**UNITED STATES OF AMERICA
BEFORE THE
FEDERAL ENERGY REGULATORY COMMISSION**

**Standardization of Generator Interconnection
Agreements and Procedures**

**) Docket No. RM02-1-000
)**

**ADDITIONAL COMMENTS OF THE
NORTH AMERICAN ELECTRIC RELIABILITY COUNCIL REQUESTING
MODIFICATION AND CLARIFICATION OF PROPOSED RELIABILITY
REQUIREMENTS**

Figure 1 – Clock Hour Integrated Energy Inadequate to Measure Schedule Following

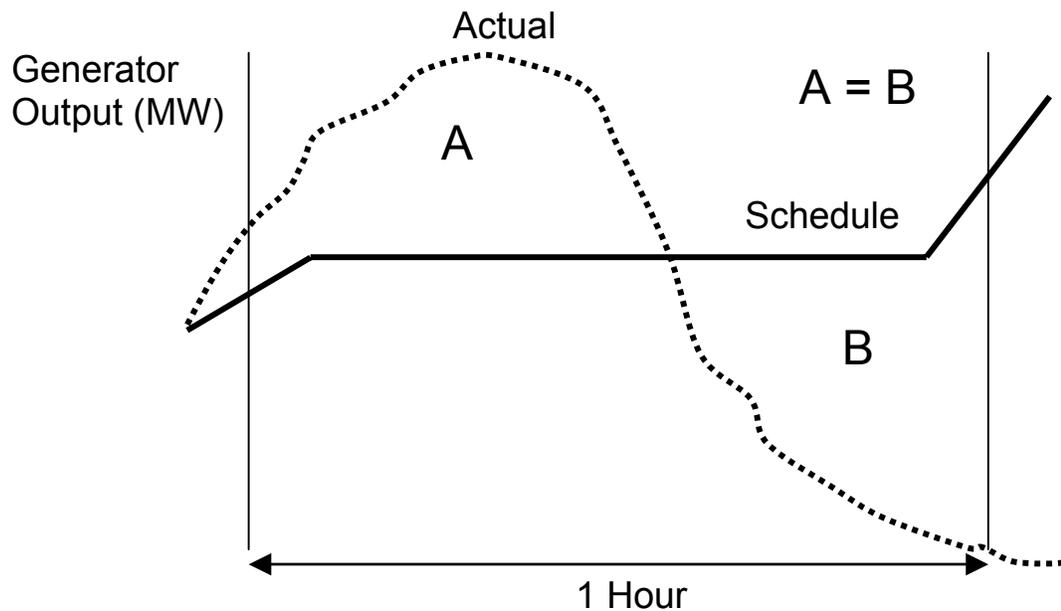
The proposed IA states that the Generator's balancing obligation is to match output with its scheduled delivery on an integrated clock hour basis. Integration of the delivered energy over an hour is a measure of delivered energy used for settlement purposes and is insufficient to describe the Generator's obligation to match its actual output with scheduled delivery continuously within a scheduling period. Furthermore, a scheduling period could be some duration other than a clock hour.

As shown in the conceptual diagram in Figure 1, a Generator can match its actual output over an hour with its integrated clock hour scheduled delivery, yet substantially over-generate for

part of the hour and under-generate for part of the hour. If such intra-hour imbalances become accepted practice, they could cause performance control problems such as frequency excursions, unscheduled power flows on the bulk electric system, and conditions that are unsafe or that have not been studied.

While modest deviations between the Generator's actual output and scheduled delivery can be expected, the magnitude and duration of these mismatches are generally regulated by market or tariff mechanisms designed to encourage good control, such as imbalance penalties.

Increasingly, markets are adopting scheduling periods other than a clock hour, including the use of a five-minute real-time balancing market in the Standard Market Design. Bulk electric system reliability depends on such market mechanisms to ensure that Generators continuously follow, within reasonable deviations, their scheduled delivery of energy, including ramps, and ancillary services.

Generator is responsible for ensuring consistent with the scheduling requirements of the Transmission Provider's FERC-approved tariff and any applicable FERC-approved market structure, that its actual Facility output matches the scheduled delivery from the Facility, ~~on an integrated clock hour basis~~, to the Transmission Provider's Transmission System, including ramping into and out of such scheduled delivery, as measured at the Point of Interconnection.
